# Service Kit 759-04143

Subject: Service Replacement for the  
42" RZT Right Hand (RH)  
Hydro Transmission.

(See Figure 1)

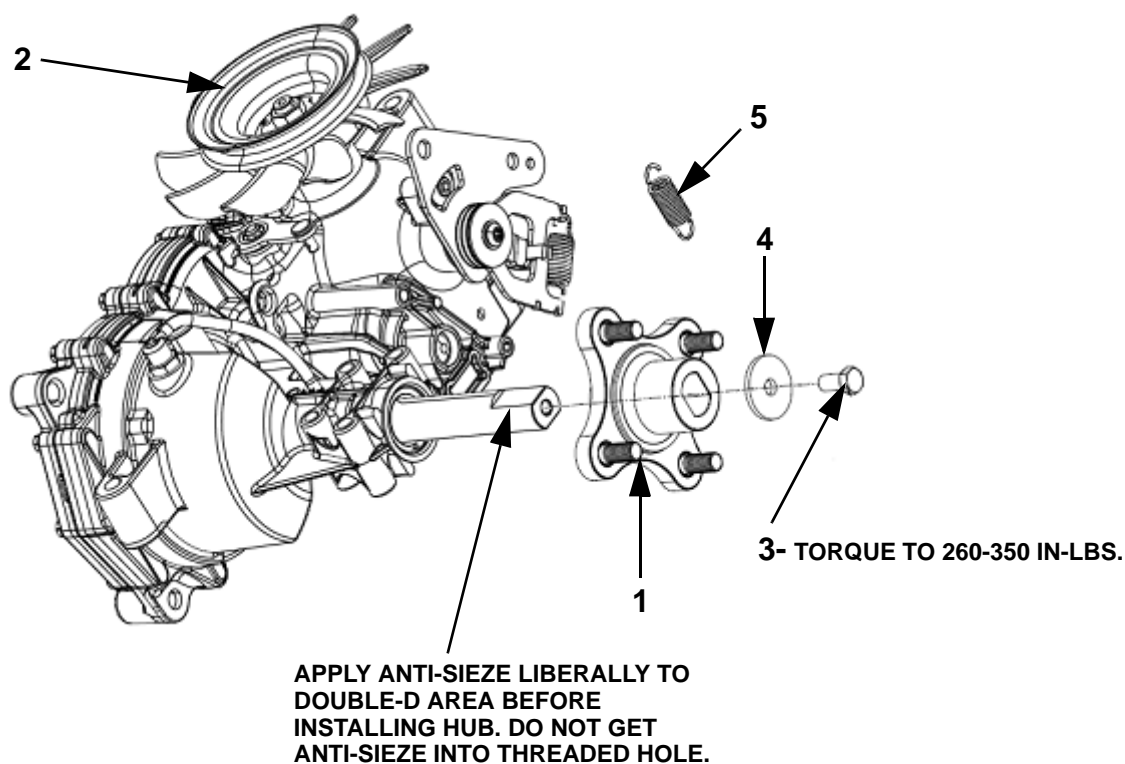
**PURPOSE:** This service kit replaces the RH hydro transmissions 618-04163A and 618-04326 which are no longer available. The replacement transmission has a Double-D axle end which requires a Double-D wheel hub assembly. A new neutral return spring is enclosed for the LH transmission. See instructions on page 2 of this sheet.

**FIGURE 2**

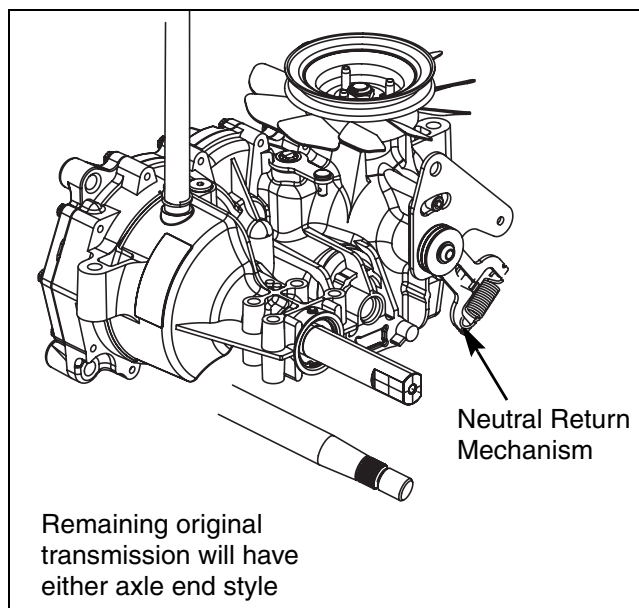
3. See Figure 2 for location of the neutral return mechanism.

**FIGURE 3**

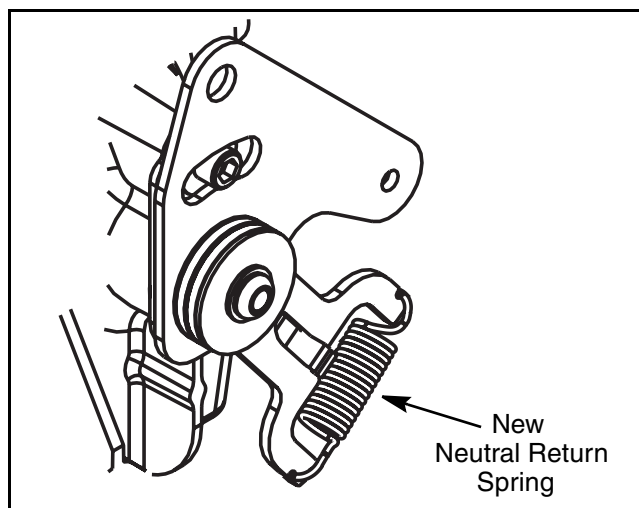
4. With a suitable set of pliers or spring removal tool, remove and discard the existing spring from the neutral return mechanisms two arms on the remaining (not replaced with this kit) hydrostatic transmission. See Figure 3.

5. Install the new Neutral Return Spring, Item 5, onto the two arms as shown in Figure 3.

6. When complete both installed transmissions must have the same color neutral return spring.
